MAGNOLIA SPRINGS SUBDIVISION, PHASE II

APPLICATION NUMBER 1 DATE August 19, 2010

REQUEST Subdivision

DETAIL SITE PLAN

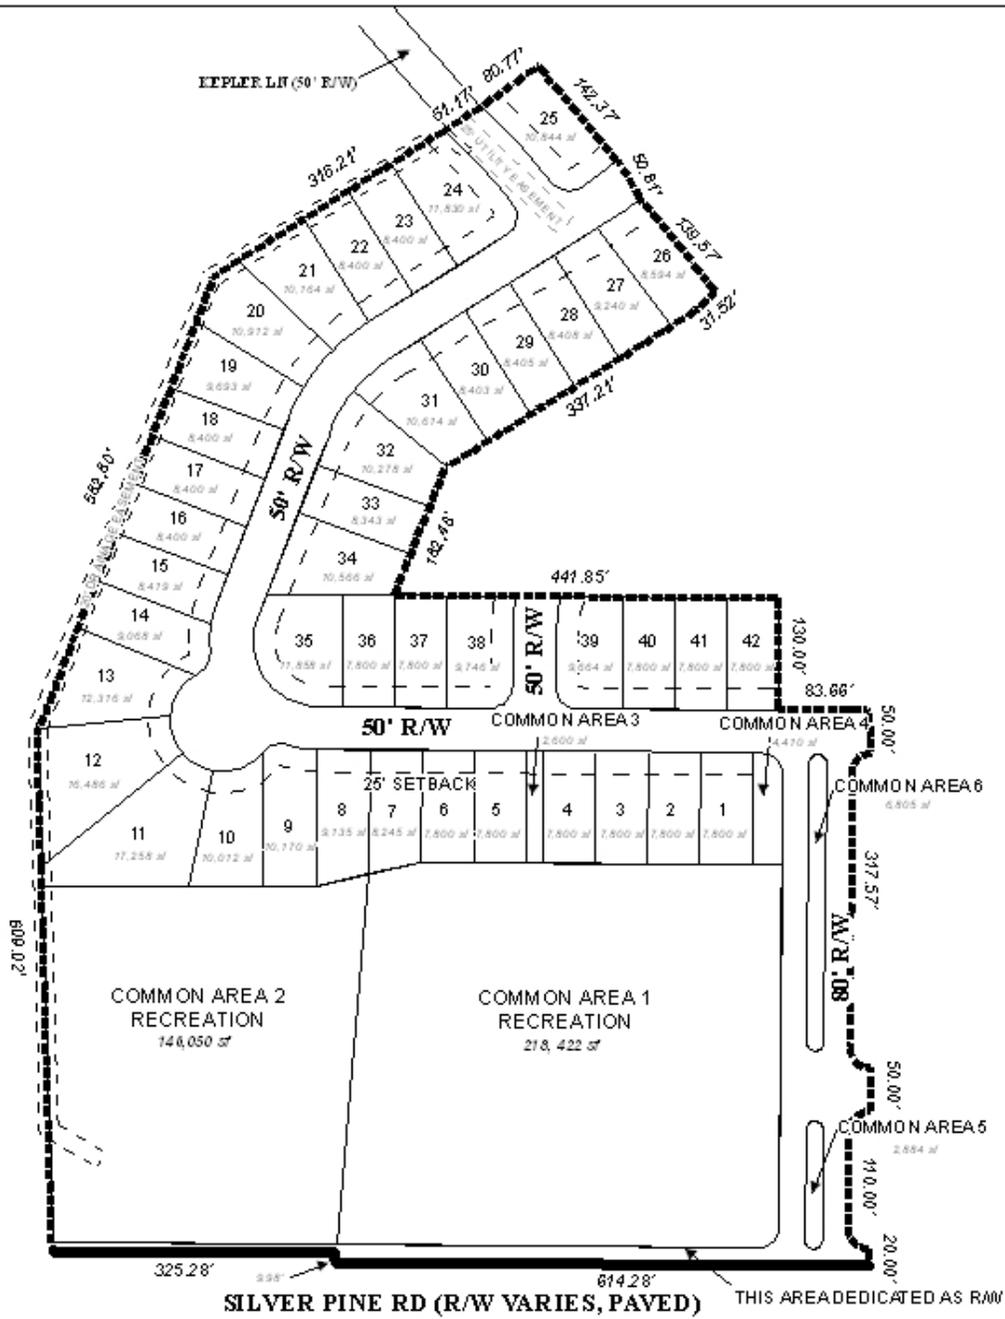
The site has frontage onto Silver Pine Road, a proposed major street. The plat depicts dedication of right-of-way sufficient to provide a minimum of 50-feet from the centerline of Silver Pine Road where it is a proposed major street, and additionally dedicates 30-feet from the projected non-major street centerline of Silver Pine Road.

New road construction is proposed. Any new roads for the site must be constructed to meet County Engineering standards and be dedicated to Mobile County for maintenance. Additionally, all lots should be limited to one curb-cut each, with the size, design and location to be approved by County Engineering, and should be denied direct access to Silver Pine Road.

All lots are labeled with their size in square feet, and the 25-foot setback line is depicted on the plat, as is a note indicating the required front minimum building setback.

Six common areas containing a total of 8.59 ± acres are depicted on the plat. The two primary common areas will be used for storm water detention and recreation. The common areas are labeled, and provision of a note on the Final Plat stating that maintenance of all common areas is the responsibility of the property owners.

Based upon the preceding, the plat meets the minimum requirements of the Subdivision Regulations and is recommended for Tentative Approval, subject to the following conditions:

- 4) common areas should be labeled and a note placed on the Final Plat stating that maintenance of all common areas is the responsibility of the property owners;

- 5) retention of the 25-foot minimum building setback line on all lots;
- 6) placement of a note on the Final Plat stating that the all lots, are denied direct access to Silver Pine Road and are limited to one curb cut, with the size, design and location to be determined by County Engineering and conform to AASHTO standards;

- 7) retention of the labeling of the size of the lot, in square feet, or provision of a table on the Final Plat with the same information;
